JOINT REGIONAL PLANNING PANEL (Sydney West Region)

| JRPP No | 2015SYW170 |
| DA Number | 576/2016/JP |
| Proposed Development | THREE LOT SUBDIVISION, CONSTRUCTION OF YORK ROAD AND ALESSANDRA DRIVE AND CONSTRUCTION OF THREE RESIDENTIAL FLAT BUILDINGS (311 DWELLINGS) ON PROPOSED LOTS 1 AND 2 AND A CHILD CARE CENTRE (100 PLACES) ON PROPOSED LOT 3. |

ATTACHMENT 6 – LEVEL 4 PLAN WITH ZONE BOUNDARY

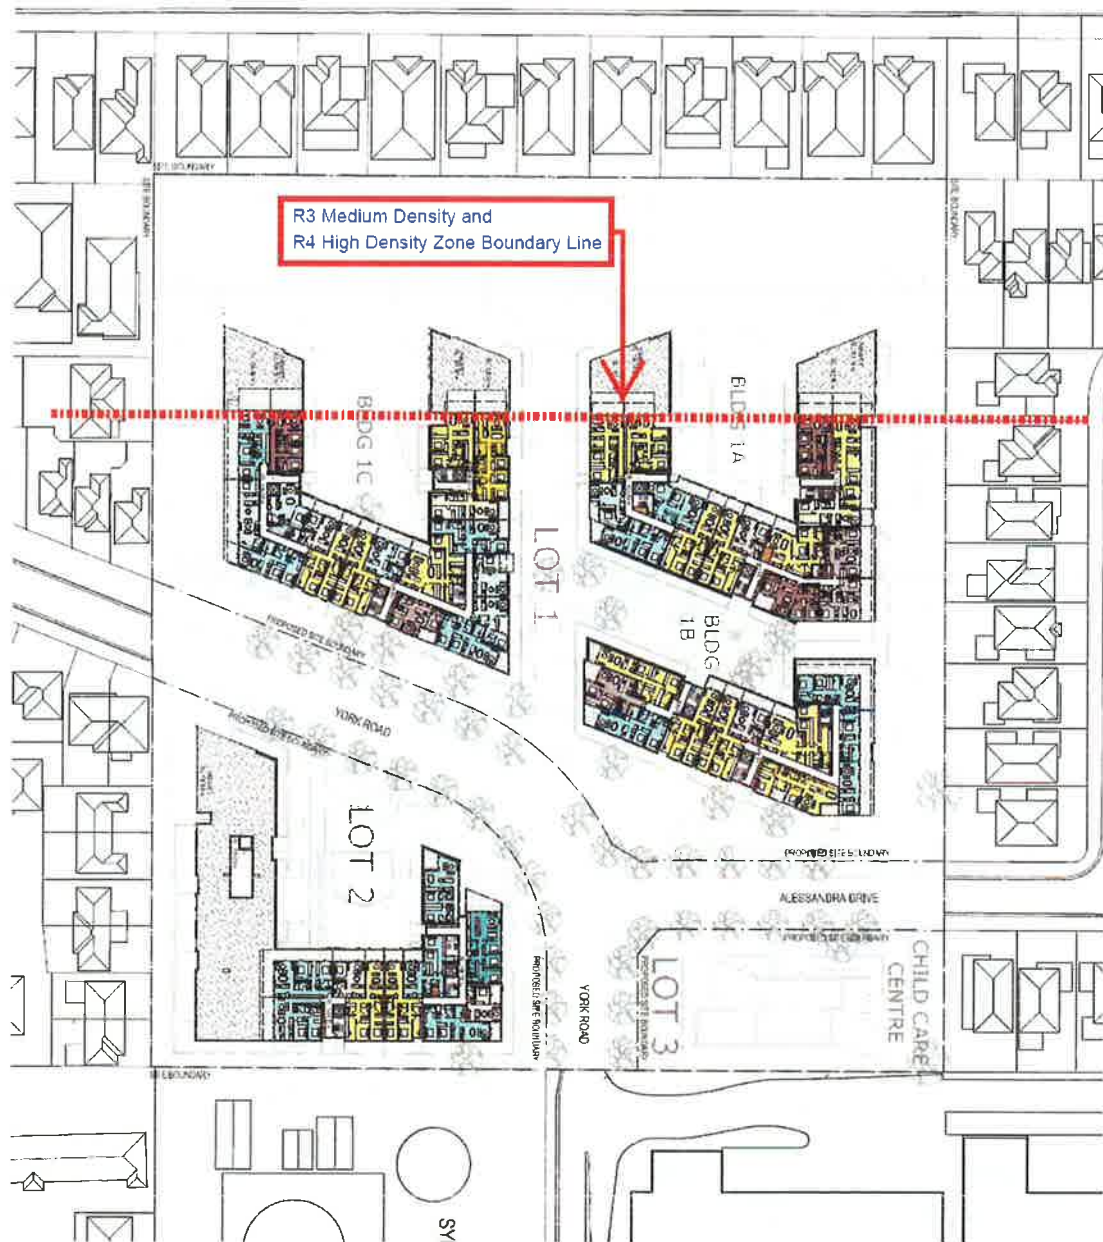
The application relies on the use of Clause 5.3 of the LEP (Development near zone boundaries) to allow a portion of the residential flat building component of the application within the R3 Medium Density Zone. The clause allows a development allowed in an adjoining zone to be permitted for up to a distance up to 20 metres. The application of the clause is considered reasonable in one respect but it is considered inappropriate to use this clause to achieve a higher density over that part of the site (20 metre wide portion of the site zoned R3 Medium Density with an area of 4,020m²). The uplift in density is further exasperated due to the utilisation by the applicant of the land area of the child care centre lot (2,187m²) for the purposes of density calculations.

1. The reliance on Clause 5.3 of The Hills Local Environmental Plan 2012 - Development Near Zone Boundaries to justify a higher density of development across the entire site is inappropriate and provides a more intense development than permitted.
(Section 79C(a)(i) of the Environmental Planning and Assessment Act 1979).
